**SUBMITTAL TO THE BOARD OF SUPERVISORS  
COUNTY OF RIVERSIDE, STATE OF CALIFORNIA**

**ITEM: 3.45  
(ID # 20747)**

**SUBJECT:** TRANSPORTATION AND LAND MANAGEMENT AGENCY/TRANSPORTATION:  
Introduction of Ordinance No. 461.11, Amending Riverside County Ordinance No. 461 Relating to the County Road Standards and County Standard Specifications. CEQA Exempt per State CEQA Guidelines section 15061(b)(3). All Districts. [\$0]

**MAJOR HIGHWAY  
(118' R/W)**

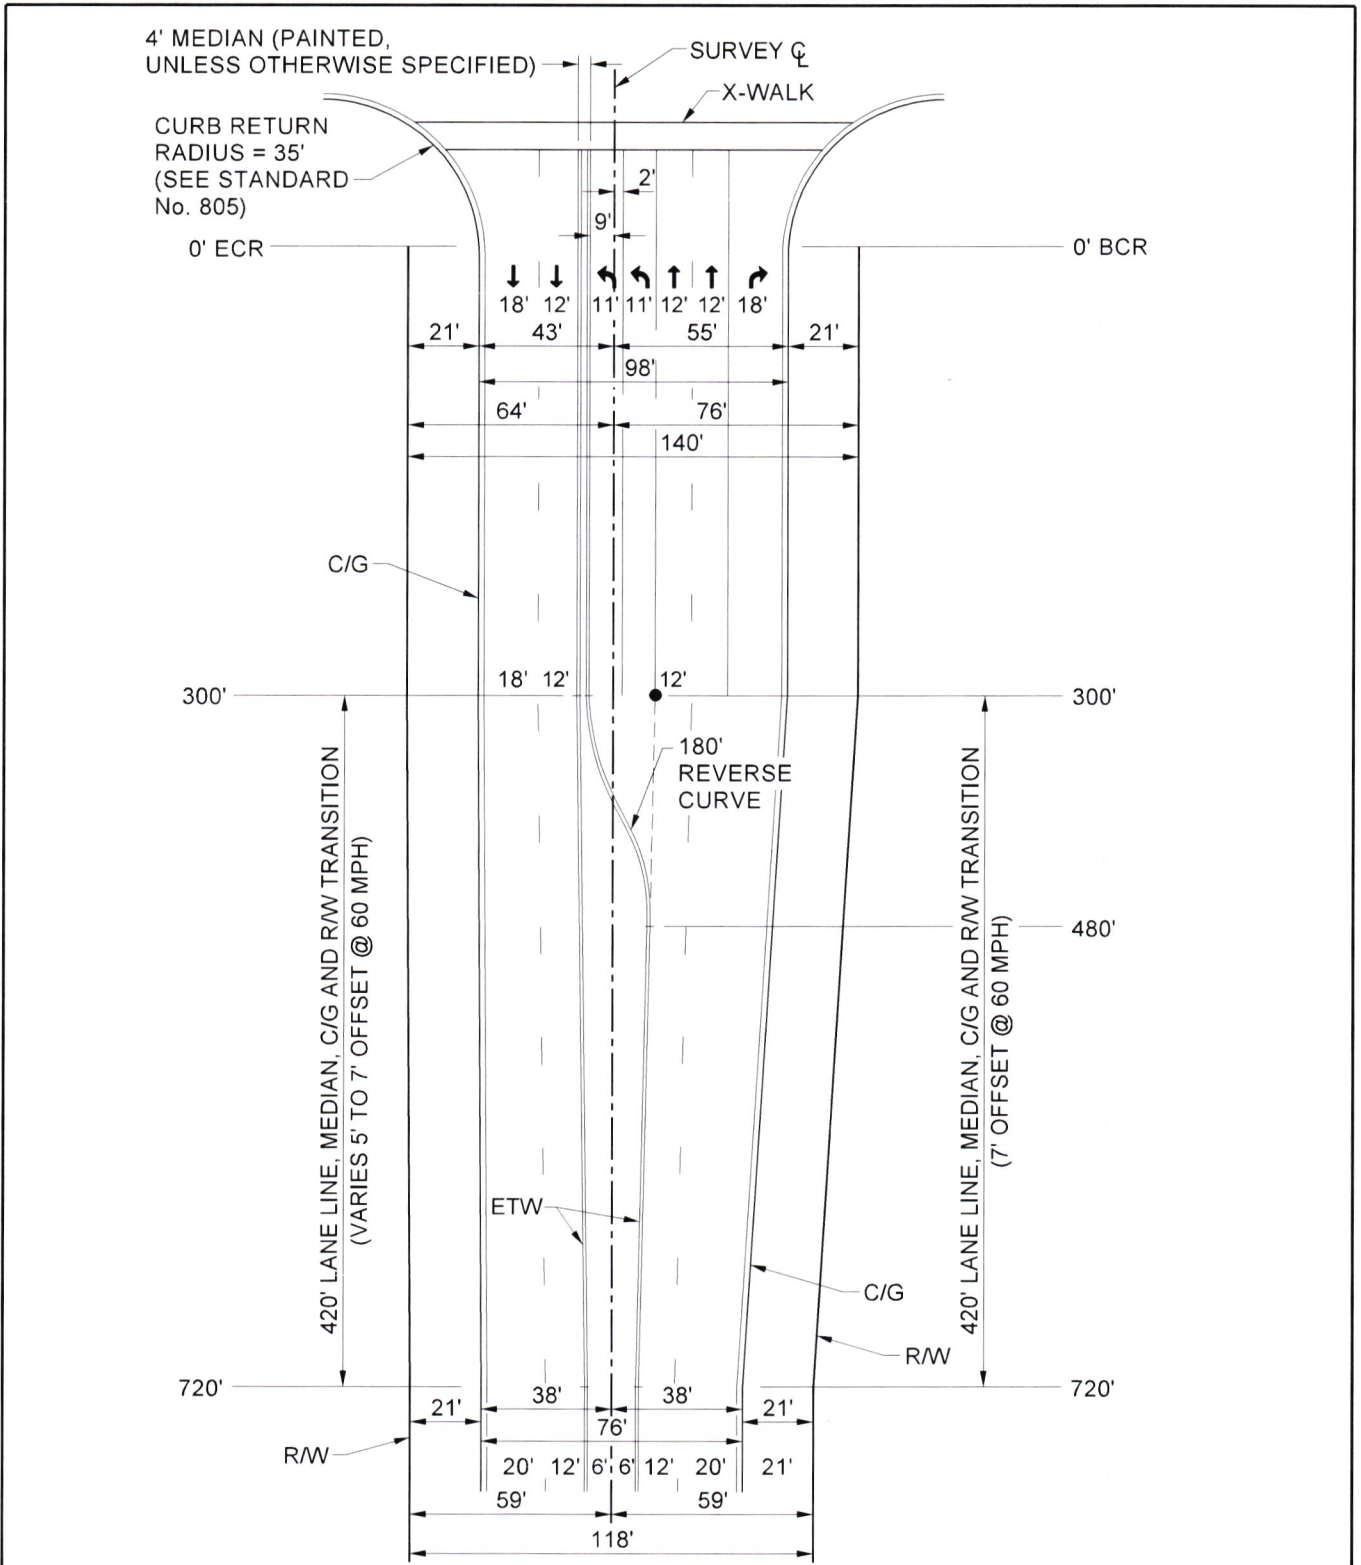
22	93-2	Major Highway (118' R/W)					X	X								X	Remove curve in approaching curb and use straight transition.
23	94-1	Secondary Highway (100' R/W)					X	X	X						X	X	
24	94-2	Secondary Highway (100' R/W)					X	X								X	Remove curve in approaching curb and use straight transition.
25	95	Mountain Arterial Highway (110' R/W)					X	X							X	X	
26	103	Collector Street (No Access)	Collector Street (No Access) (74' R/W)				X	X	X	X					X	X	
27	104	Enhanced Local Street Adjacent To School or Park	<b>104-1</b> Enhanced Local Street Adjacent To School or Park (66' R/W)			X	X	X	X	X					X	X	Modified Section "B" to include curb & gutter on both sides.
			<b>104-2</b> Enhanced Local Street Adjacent To School or Park (66' R/W)		X												
28	105-1	Local Street (56' R/W)	<b>105B</b> Short Local Street (56' R/W)				X	X	X	X					X	X	Renumbered old Std 105-1 to Std 105B. Added curb & gutter.
29	105-2	Local Street (60' R/W)	<b>105A</b> Exterior & Local Street (60' R/W)				X	X	X	X					X	X	Renumbered old Std 105-2 to Std 105A. Added curb & gutter.

**SAFETY EDGE**

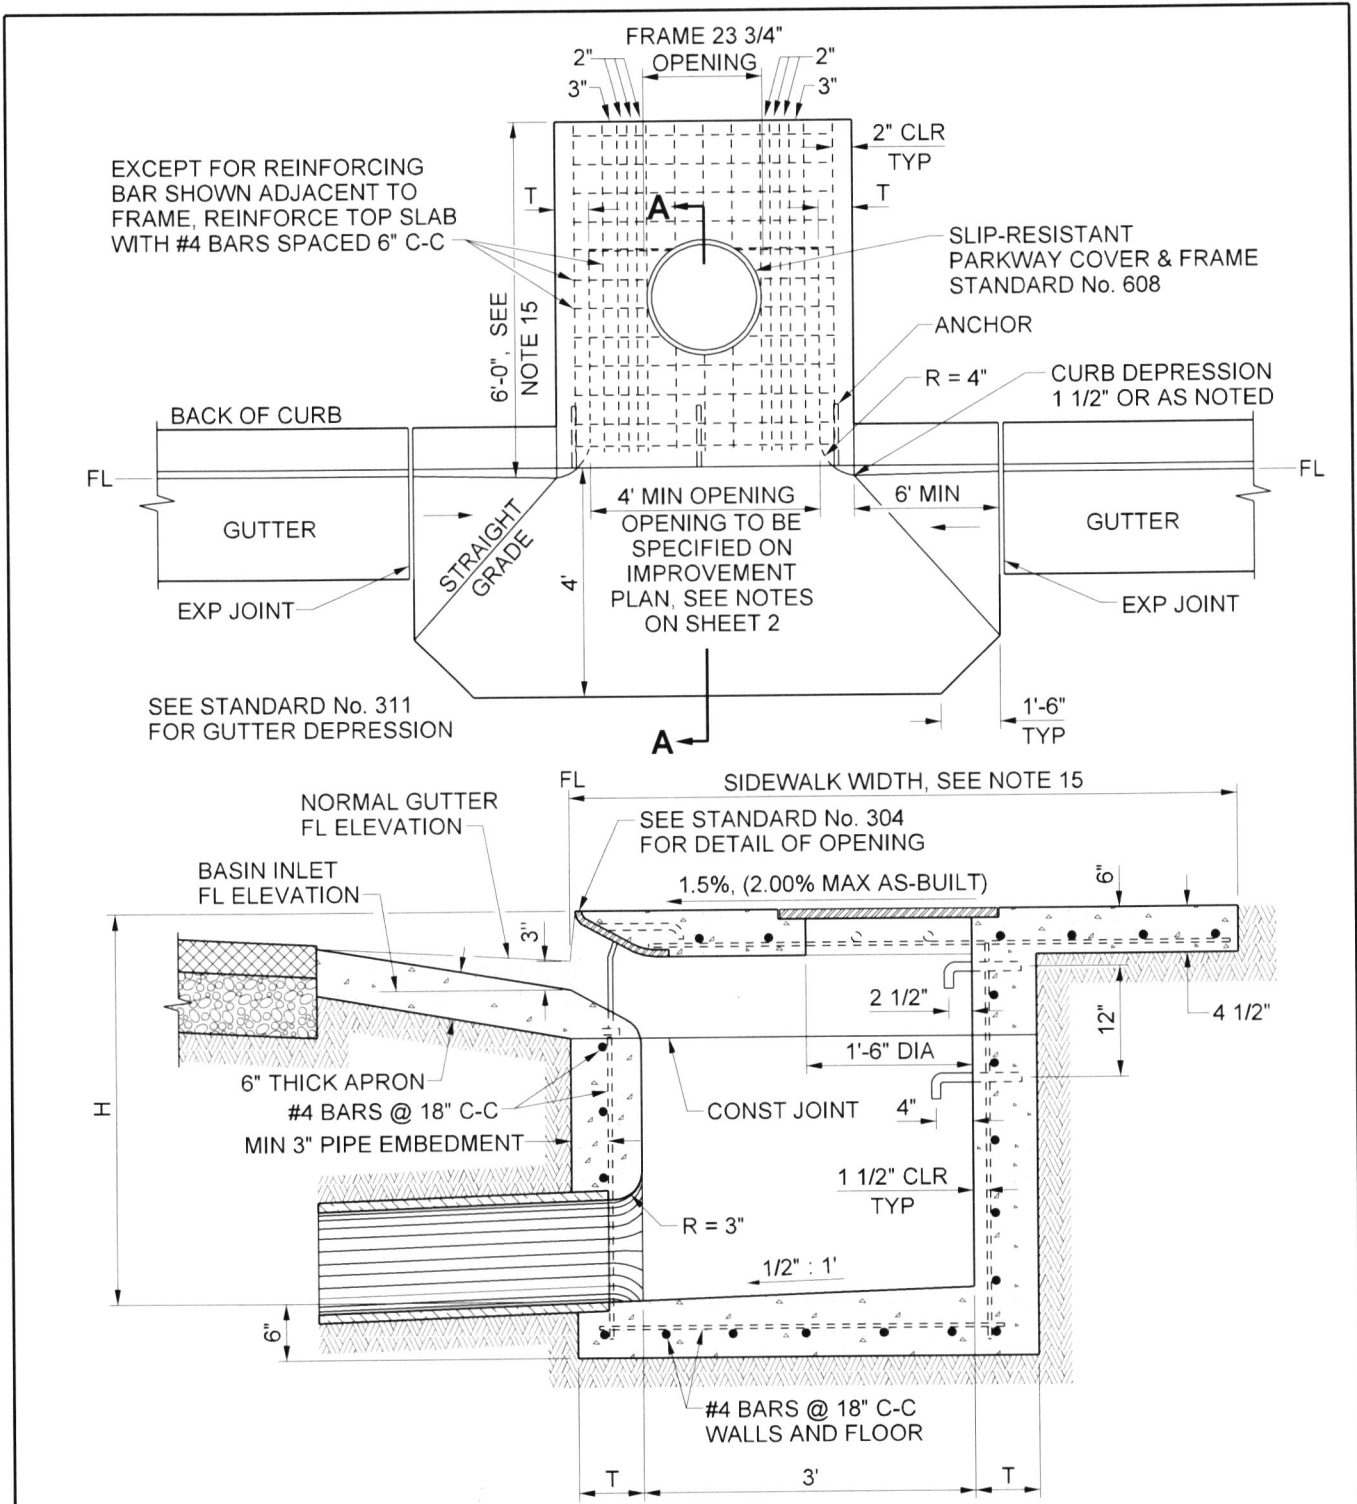
10. Added a bicycle-safe drainage grate detail to improve safety for bicyclists.
11. Added a new standard for the Safety Edge treatment of the outer edge of roadways to improve vehicle recovery and traffic safety.

Page No. in 2007 Riv Co Road Stds PDF	Std No.	Ordinance No. 461.10 (2007)	Ordinance No. 461.11 (NEW)	Deleted Standard	Added New Standard	Combined or Split Sheets	Applied Revised Border, Title Block	Reformatted Drafting	Modified Title of Standard	Updated Accessibility (ADA) Compliance	Removed Plastic Sheeting (See Std 401)	Added Subgrade Compaction Note	Updated Soil Note	Modified/Added Concrete Specification	Modified the Notes Section	Other Changes to Text, Details	Additional Notes / Comments
		Road Std Title	Road Std Title														
63	213	Residential Driveway with Sidewalk at R/W	<b>213-1</b> Residential Driveway Approach with Sidewalk at R/W			X	X	X	X	X	X	X	X	X	X	X	
			<b>213-2</b> Residential Driveway Approach with Sidewalk at R/W		X		X	X		X							Modified callout for tooled joints.
			<b>214-1</b> Safety Edge		X												Added new safety edge standard.
			<b>214-2</b> Safety Edge		X

**RIPRAP ENERGY  
DISSIPATOR AT  
V-DITCH OUTFALL**

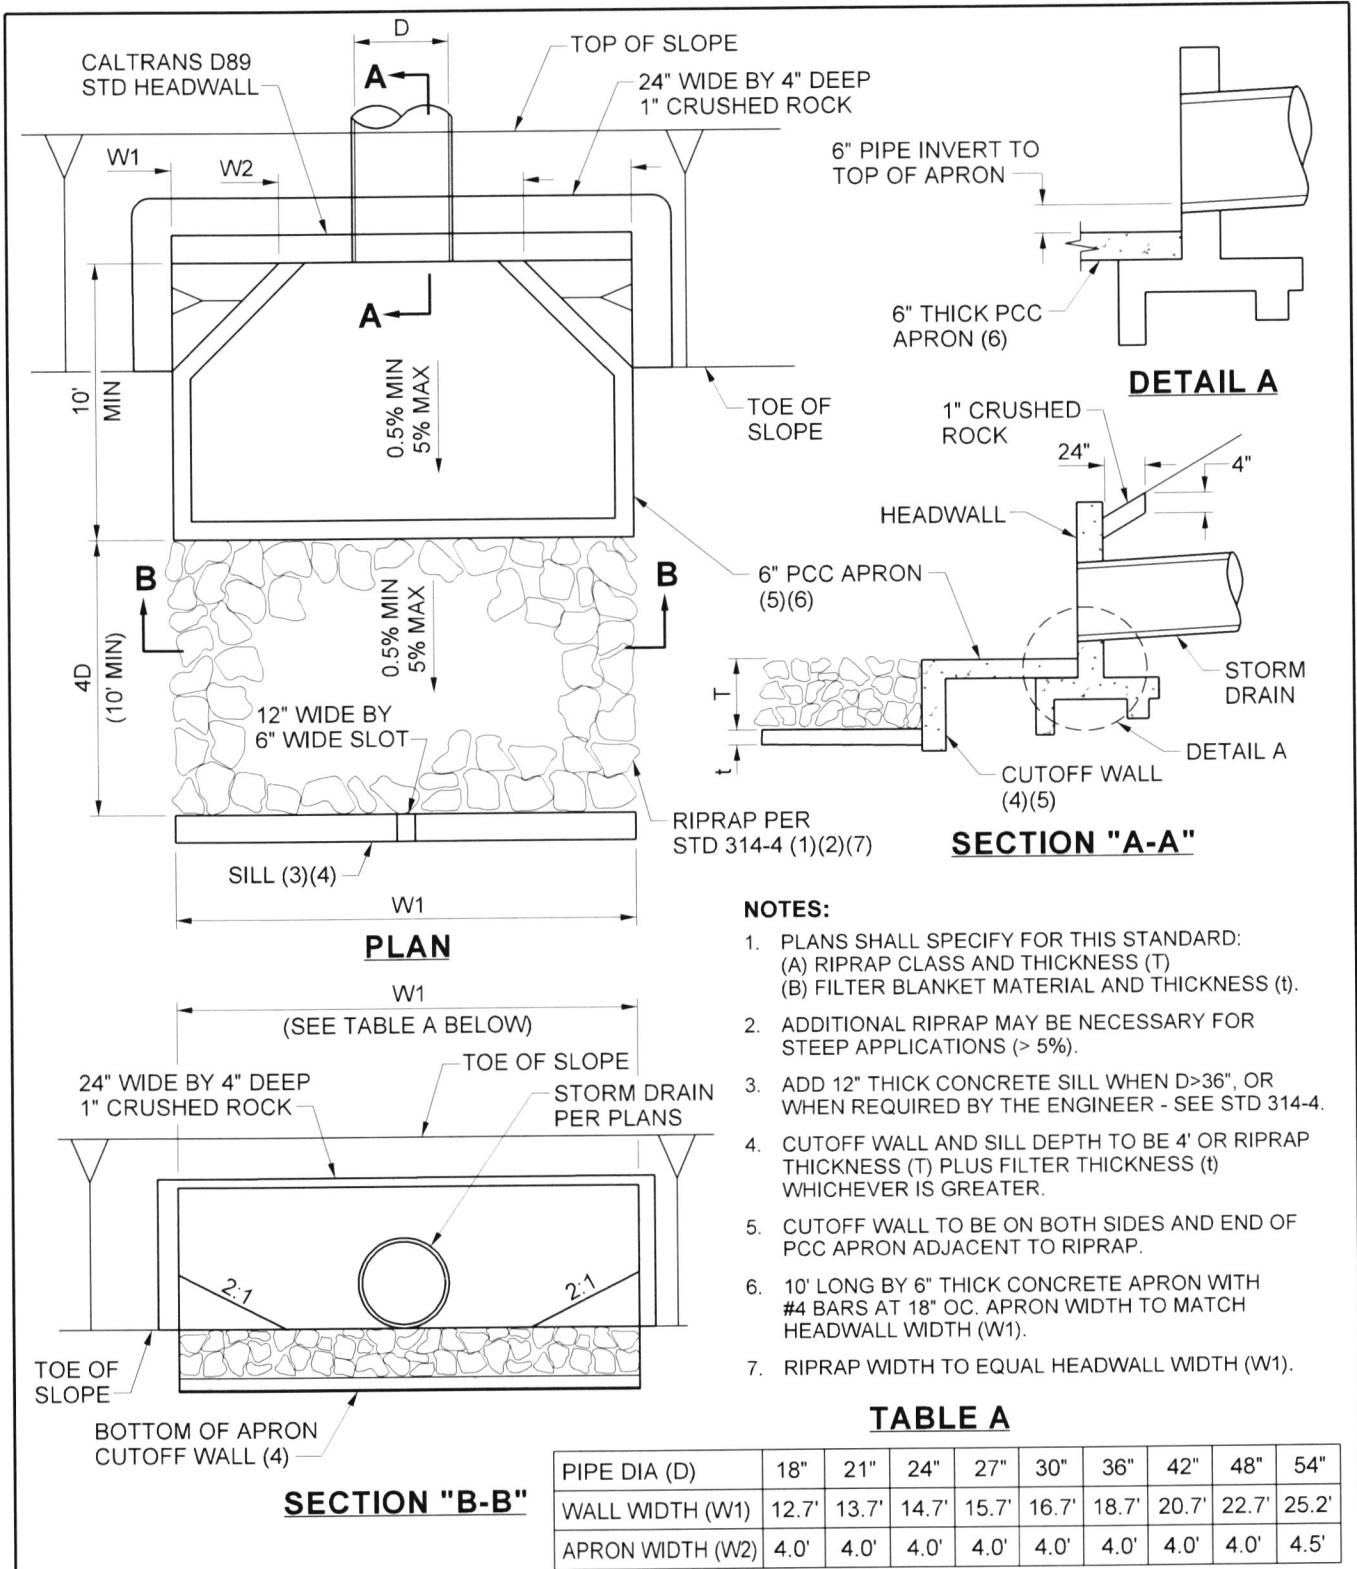
6. Added standards for riprap around storm water facilities to reduce soil erosion from impacting downstream water quality and to reduce maintenance costs associated with repairing dirt slopes and cleaning deposited soils from downstream facilities.

**CURB RAMP PROFILE**

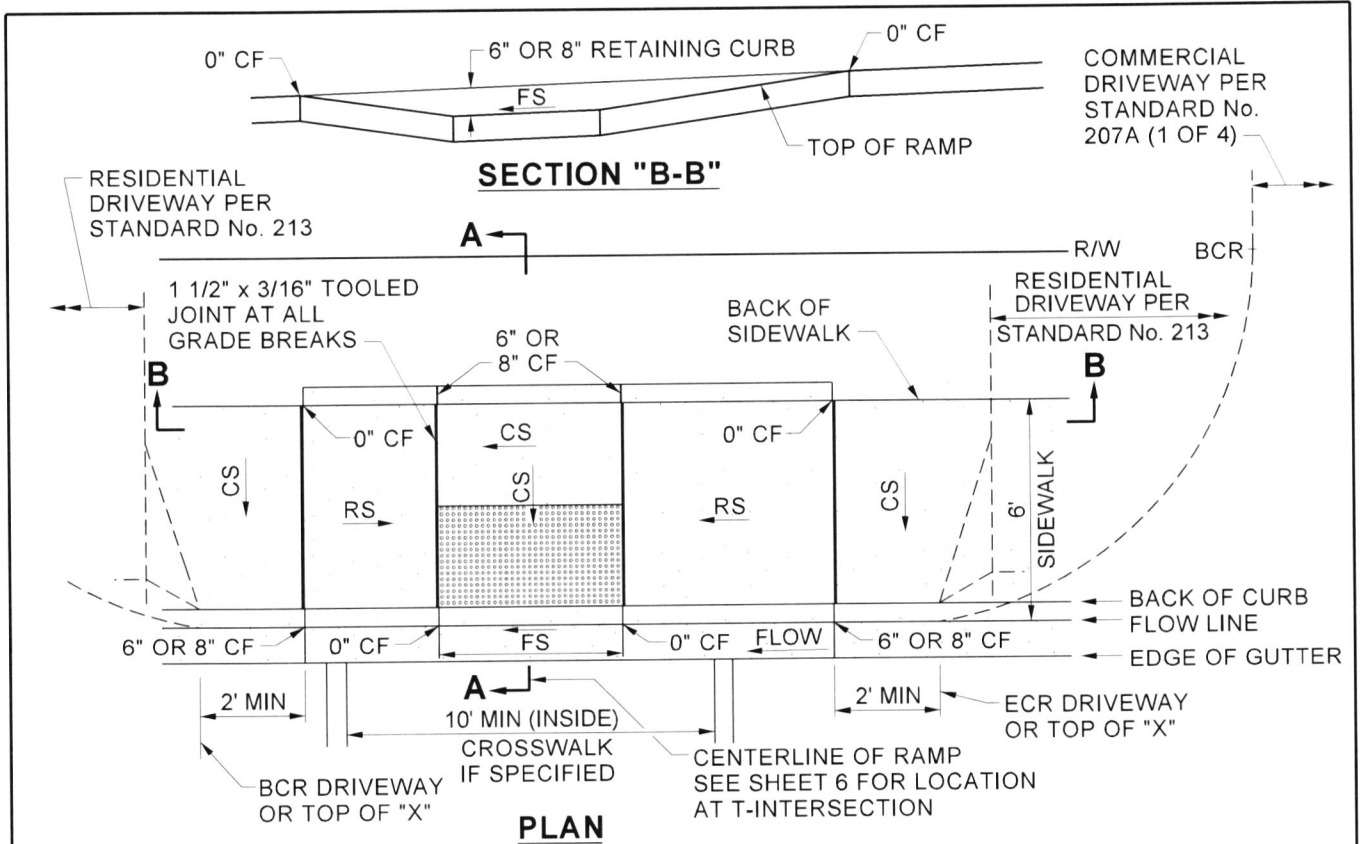
86	403-2	Curb Ramp Case B					X	X		X	X	X			X	X	Removed requirement for grooves. Called out tooled joints. Reduced ramp slope from 8.33% to 7.5%. Reduced cross slope from 2.00% to 1.5%.
87	403-3	Curb Ramp	Curb Ramp Profile				X	X	X	X						X	Modified the table (Case A) for revised slopes. Added a table for Case B and Case C.
88	403-4	Curb Ramp Construction Notes	403-7 Curb Ramp Notes				X	X	X	X			X	X	X		Expanded and clarified notes.
			403-4 Curb Ramp Case C "T" Intersection with Sidewalk at Curb		X												Added a new detail for parallel curb ramp with sidewalk at curb.
			403-5 Curb Ramp Case D "T" Intersection with Sidewalk at R/W		X												Added a new detail for curb ramp with sidewalk at R/W.
			403-6 Curb Ramp Case C and D Location at "T" Intersection		X												Added a new detail to show curb ramp locations at T-intersections.
89	404	Meandering Sidewalk					X	X		X	X		X	X	X	X	Added accessibility note.

**RECTANGULAR  
MANHOLE  
FRAME AND COVER**

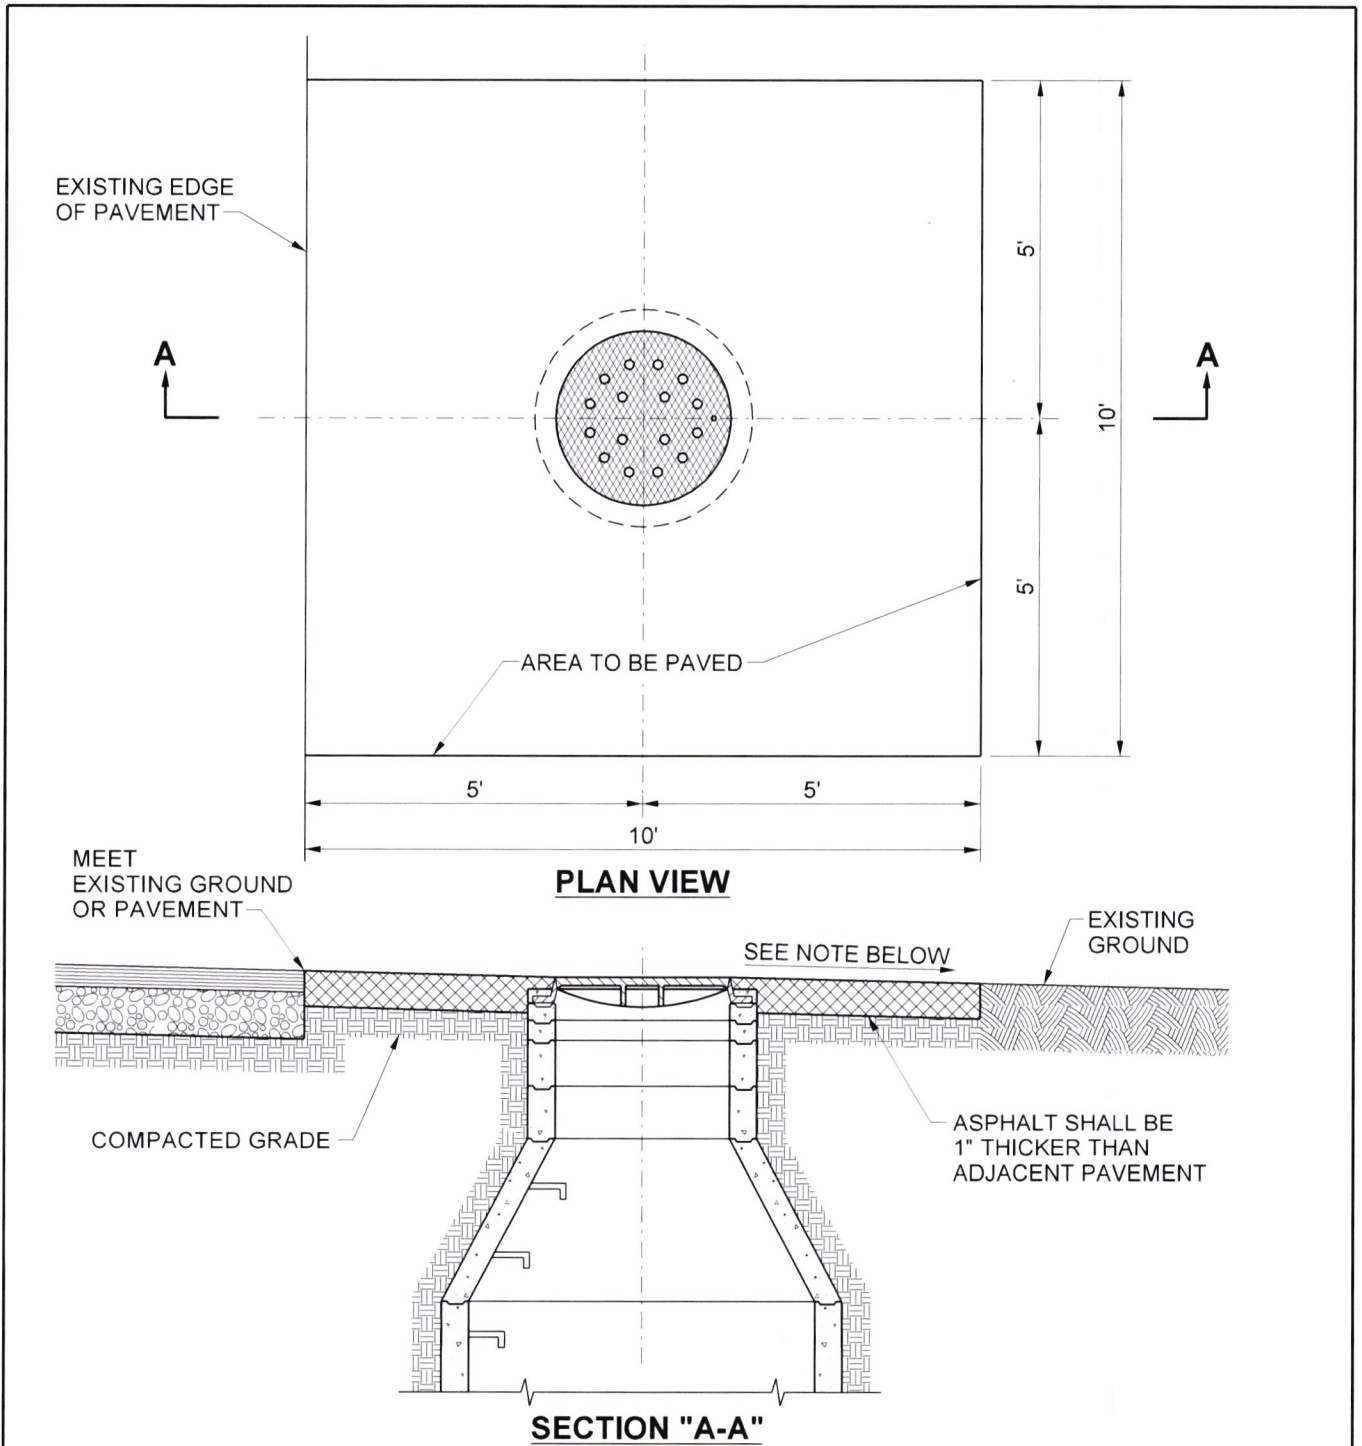
102	611	Rectangular Manhole Frame and Cover					X	X								X	Modified geometrics.
103	612	Paving Detail Around Manhole in Unpaved Area					X	X					X		X		
104	700	Typical Water Meter Installation	Water Meter Installation				X	X	X				X			X	Increased cover over water main from 36" to 48" to match Std 817.
105	701	Fire Hydrant Installation					X	X					X		X	X	Changed 18" setback from flow line to nearest part of FH. Increased cover over water main from 36" to 48" to match Std 817.
106	702	Fire Hydrant Installation (Alternate)					X	X							X		Increased cover over water main from 36" to 48" to match Std 817. Changed ordinance reference.
107	703	Valve Box, Frame and Cover					X	X									Increased cover over water main from 36" to 48" to match Std 817.
108	800	Cul-De-Sac					X	X									Added 50' R/W. Deleted 60'/20' combination row. Revised table values.
109	800A	Offset Cul-De-Sac				X	X	X									Added 50' R/W. Deleted 60'/20' combination row. Revised table values.
